PG&E Letter DCL-15-107

Diablo Canyon Units 1 and 2
Docket No. 50-275, OL-DPR-80
Docket No. 50-323, OL-DPR-82

License Amendment Request 15-07, Revision of Reactor Coolant System Minimum Flow Specified in Technical Specification 3.4.1, "RCS Pressure, Temperature, and Flow Departure from Nucleate Boiling (DNB) Limits"

Figure 2.1.1-1
REACTOR CORE SAFETY LIMIT

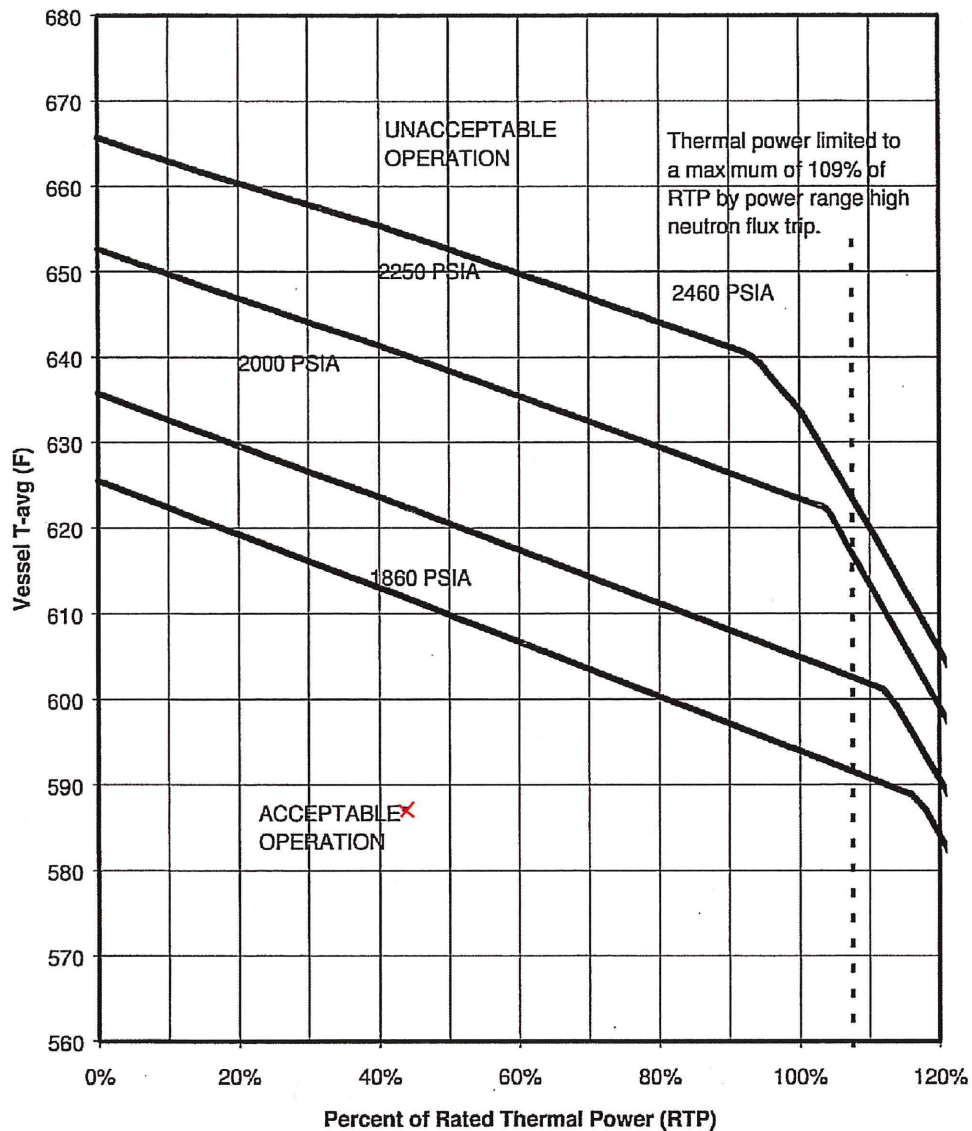
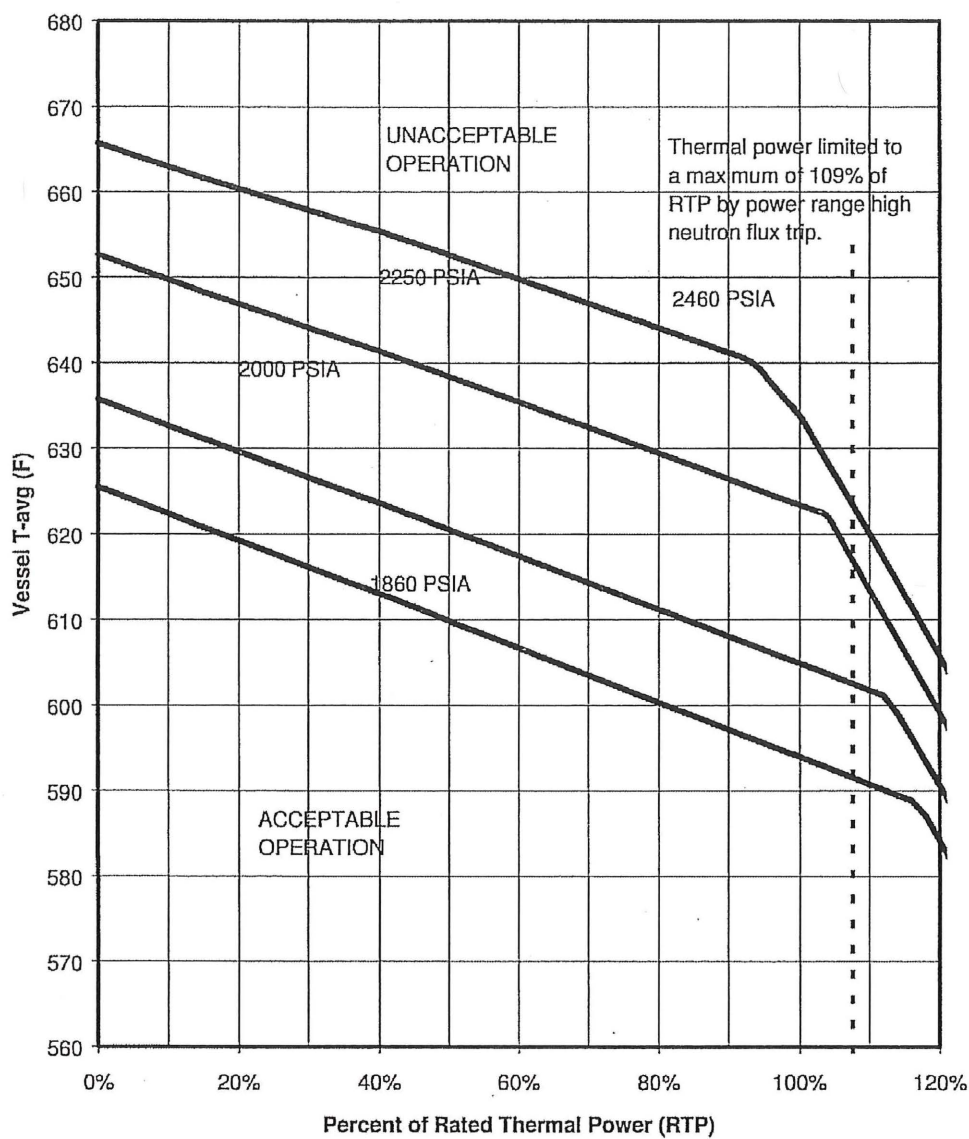
Figure 2.1.1-1, "REACTOR CORE SAFETY LIMIT," provides the SL resulting from the combination of THERMAL POWER, RCS highest loop average temperature, and pressurizer pressure. Figure 2.1.1-1 contains a note associated with the "Acceptable Operation" region specified in the figure. The Figure 2.1.1-1 note states:

"*When operating in the reduced RTP region of Technical Specification LCO 3.4.1 (Table 3.4.1-1 for Unit 1 and Table 3.4.1-2 for Unit 2) the restricted power level must be considered 100% for this Figure."

The proposed change would delete TS 3.4.1 Table 3.4.1-1 for Unit 1 and Table 3.4.1-2 for Unit 2 and revise the SL to be consistent with TS 3.4.1 in NUREG-1431. The DCPD TS 3.4.1 would then only specify the RCS flows required for 100 percent reactor thermal power (RTP) consistent with the applicable DCPD safety analyses. Therefore, the note associated with Figure 2.1.1-1 which references the reduced RTP levels contained in TS 3.4.1 Tables 3.4.1-1 and 3.4.1-2 is no longer required. As such, the proposed change includes deleting the note associated with Figure 2.1.1-1.

*When operating in the reduced RTP region of Technical Specification LCO 3.4.1 (Table 3.4.1-1 for Unit 1 and Table 3.4.1-2 for Unit 2) the restricted power level must be considered 100% for this Figure.
